Addendum to Environmental Impact Report

Addendum Date: December 13, 2012
Case No.: **2005.0161E**
Project Title: **Calaveras Dam Replacement Project**
EIR: 2005.0161E, certified January 27, 2011
Project Sponsor: San Francisco Public Utilities Commission
Lead Agency: San Francisco Planning Department
Staff Contact: Chris Kern – (415) 575-9037
chris.kern@sfgov.org

Figure 1
Cross-Section of the Left Abutment

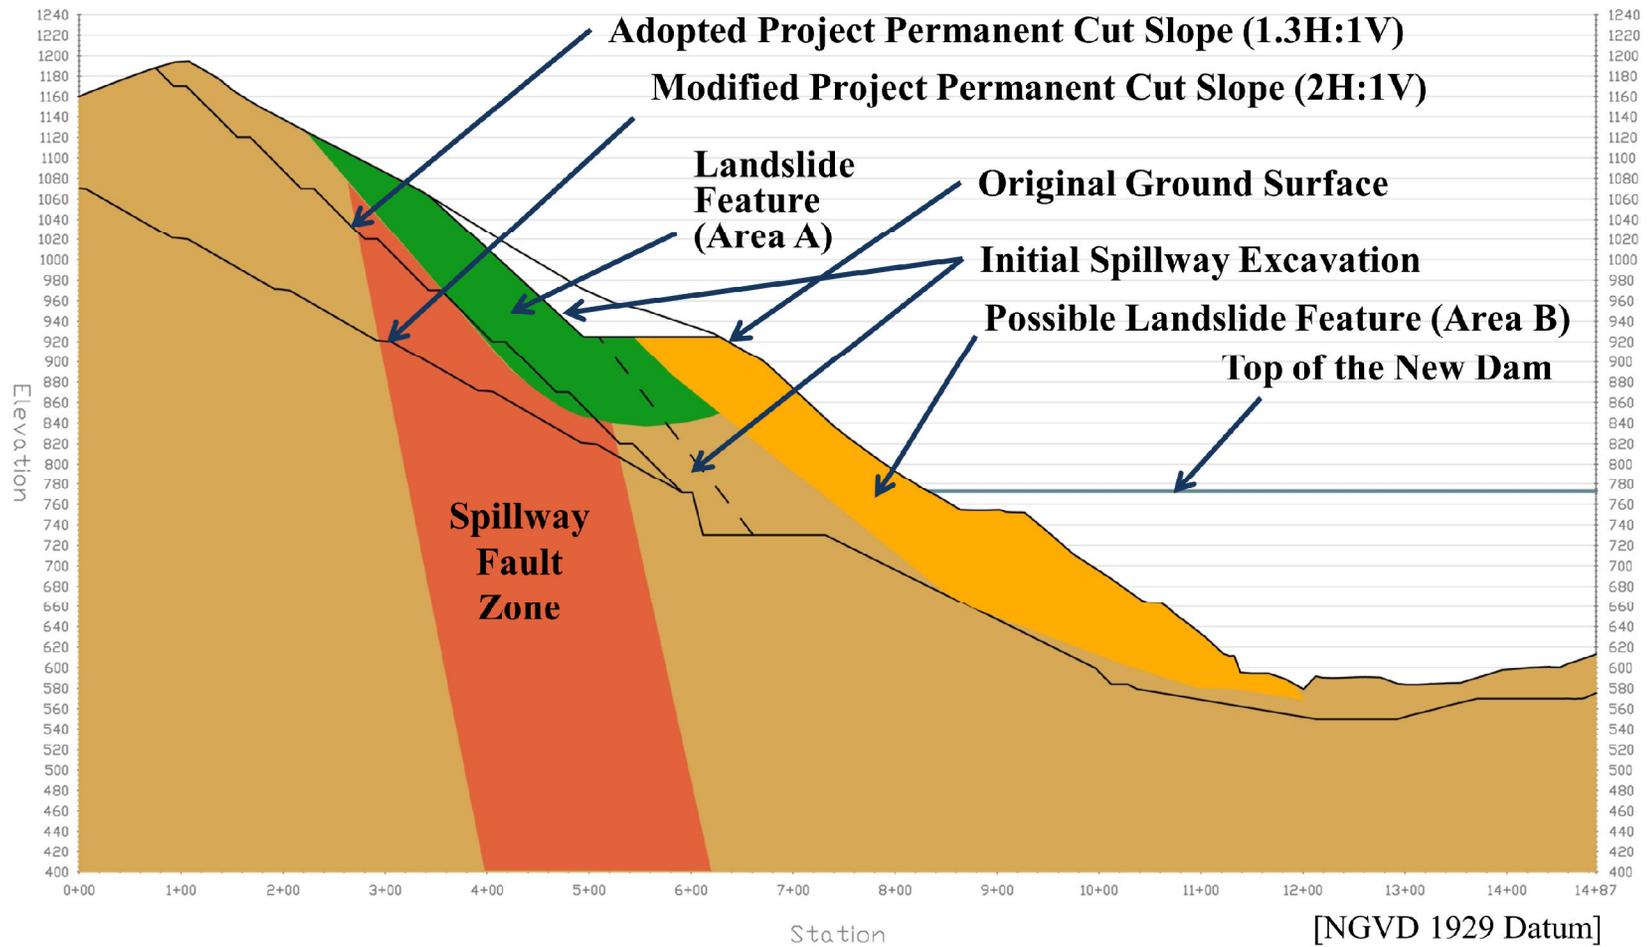
In July 2012, the SFPUC initiated a geological and geotechnical study⁵ to further evaluate the slope instability hazard affecting the left dam abutment excavation. The study found the presence of one landslide feature (Area A) and another possible landslide feature (Area B) in the spillway cut slope in Observation Hill (see **Figure 1**). The study also found that the Spillway Fault Zone, a zone of sheared and broken rock along the trace of the Spillway Fault, was much wider than originally considered during design. Due to the presence of the Area A landslide feature and the wider Spillway Fault Zone, the study recommended additional excavation of the left abutment and grading of Observation Hill from its original design slope of 1.3:1 to a less steep 2:1 slope as described under MPM No. 18 (see **Figure 1**).

Under the proposed project modifications, the SFPUC would grade the slope of Observation Hill for the spillway to an overall final slope of 2:1. The excavation of the left dam abutment slope would expand the excavation work area at the top of the slope by approximately 4.1 acres compared to the adopted project, and would be constructed between an elevation of approximately 756 feet and 1,100 feet (see **Figure 3**). The finished grade of the left dam abutment would generally consist of 12.5-foot-wide benches at 50-foot vertical intervals with slopes of 1.5:1 between benches. One of the benches, at elevation 820 feet, would have a width of 25 feet to facilitate installation of a line of 3-foot-diameter stabilization shafts up to 70 feet deep. Where needed, rock netting, rock bolts, and/or shotcrete would be placed for stabilization of the surface of the slope. The additional material to be removed and permanently disposed of by altering the 1.3:1 slope under the adopted project to a 2:1 slope proposed under the modified project would be 1.3 million cubic yards. In addition to excavating and re-grading the left dam abutment slope, an additional 410,000 cubic yards of material related to the unexpected geological features in the dam foundation is expected to require removal. This would result in a total of 1.71 million cubic yards of additional excavation and permanent disposal compared to the adopted project. The left dam abutment work also would require excavation and temporary stockpiling of an additional 1.4 million cubic yards of material compared to the adopted project. This material would be stockpiled temporarily at Disposal Site A/D until it is needed for construction of the dam foundation.

Figure 3
Modified Project Components

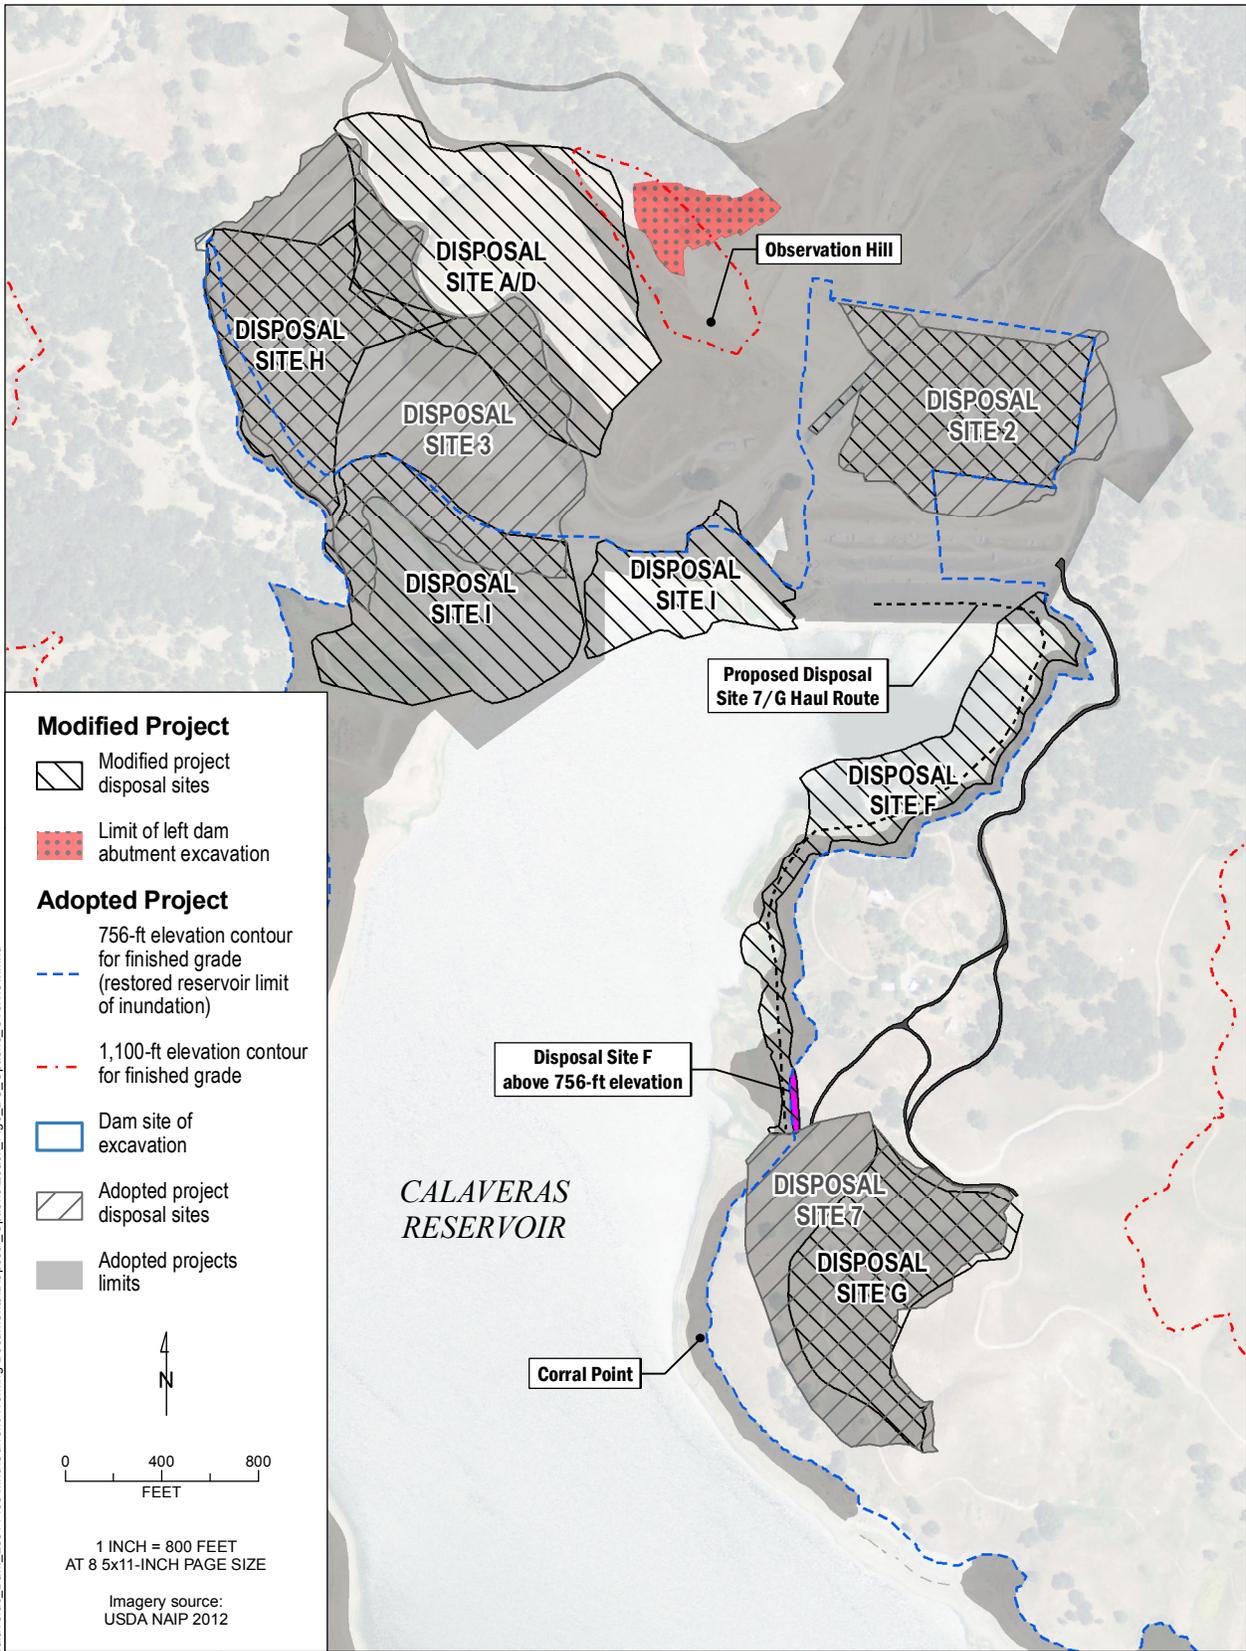
In addition to the five new disposal sites, the SFPUC proposes to expand the capacity of Disposal Site 2 from 900,000 cubic yards as described in the EIR for the adopted project to 1.3 million cubic yards. Disposal Site 2 is located in the area between the existing dam (which would serve as a cofferdam during construction) and the replacement dam. As shown on Figure 3, all of the additional spoils proposed to be placed at this site would be located within the 13.9-acre portion of the site that would be below the 756-foot future inundation level of the restored reservoir. As the full scope of the project modifications required to address the landslide hazards was developed, the work proposed under MPM Nos. 18, 19, and 20 was further refined and incorporated into the project modifications addressed in this addendum and further described below.

In terms of sequence of use, proposed Disposal Sites A/D would most likely be used first. Concurrently, turbidity barriers would be placed in the reservoir so that Disposal Sites F and I, which are located partially within the reservoir, could begin to be filled. Once filled, Disposal Site F would provide a temporary haul route to both the approved Disposal Site 7 and proposed Disposal Site G, and would avoid the need to construct a separate upland haul road to Disposal Site 7 as described in the EIR for the adopted project. Thus, Disposal Site F would need to be complete before materials for disposal could be hauled to Disposal Sites 7 and G. Disposal Sites H and 2 would likely be used last.
